1. Identification of Change

**WOLF CREEK GENERATING STATION
UNIT NO. 1
FINAL SAFETY ANALYSIS REPORT**

FIGURE 17.2-1

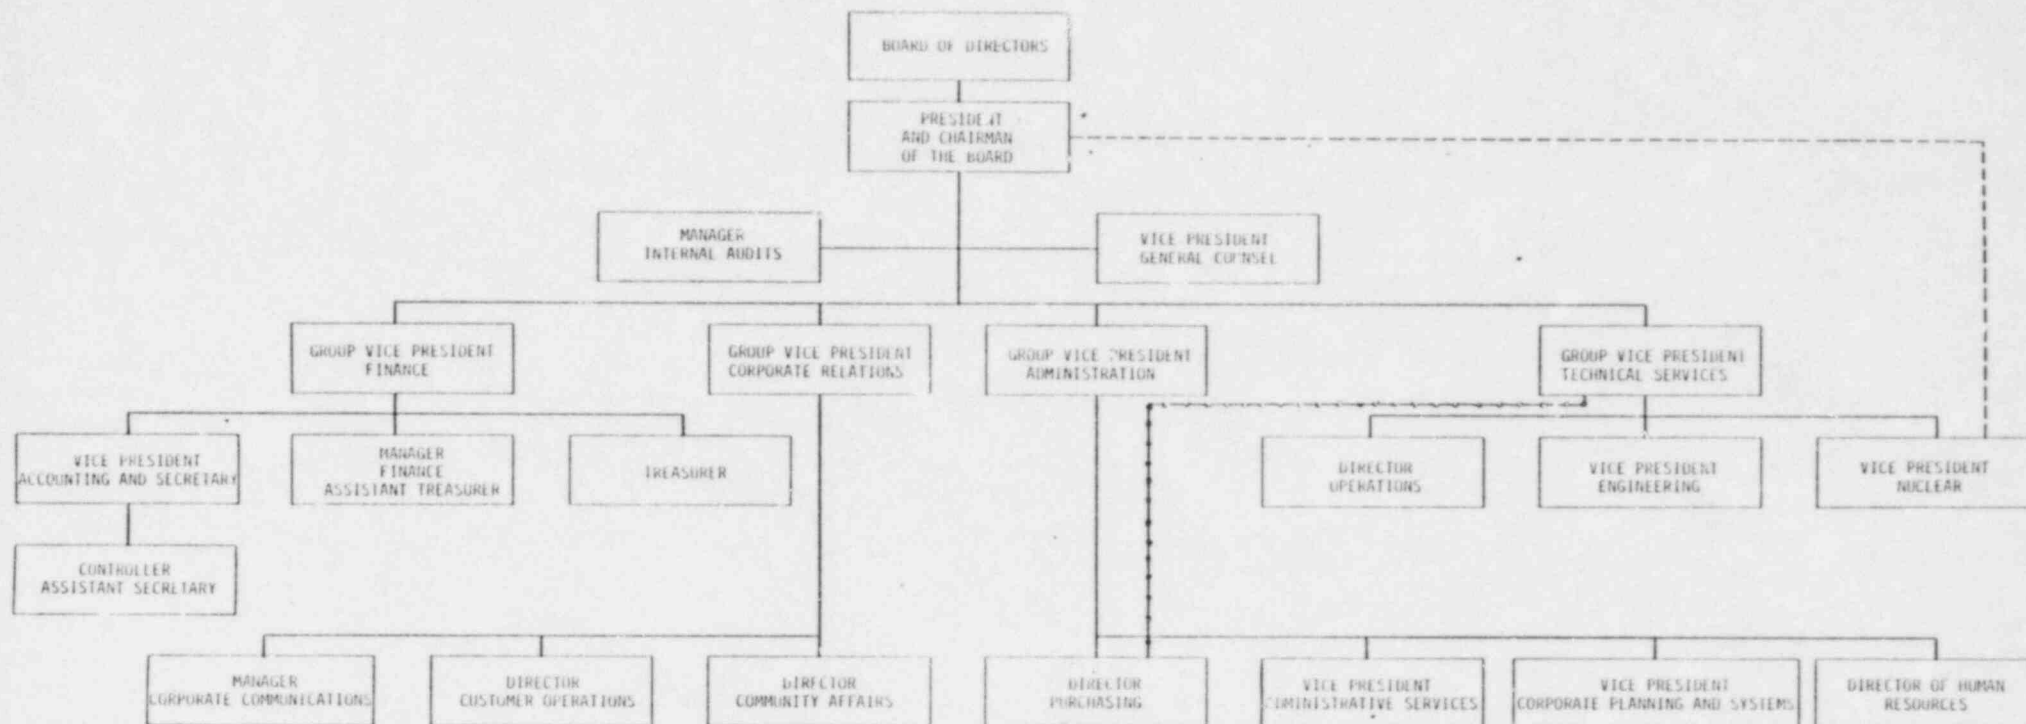
Pages 17.2-3 (Sections 17.2.1.2, 17.2.1.2a, 17.2.1.3),
17.2-4 (Sections 17.2.1.3a), 17.2-5a, 17.2-6,
and 17.2-8 (paragraph 1)
Figures 17.2-1 and 17.2-2

The revised pages update the organizational description and titles of KG&E personnel.

The revised organization description provides delineation of the authority and duties of positions performing activities affecting the safety-related functions of structures, systems and components. The organizational elements performing quality assurance functions maintain sufficient authority and independence as required by Appendix B.
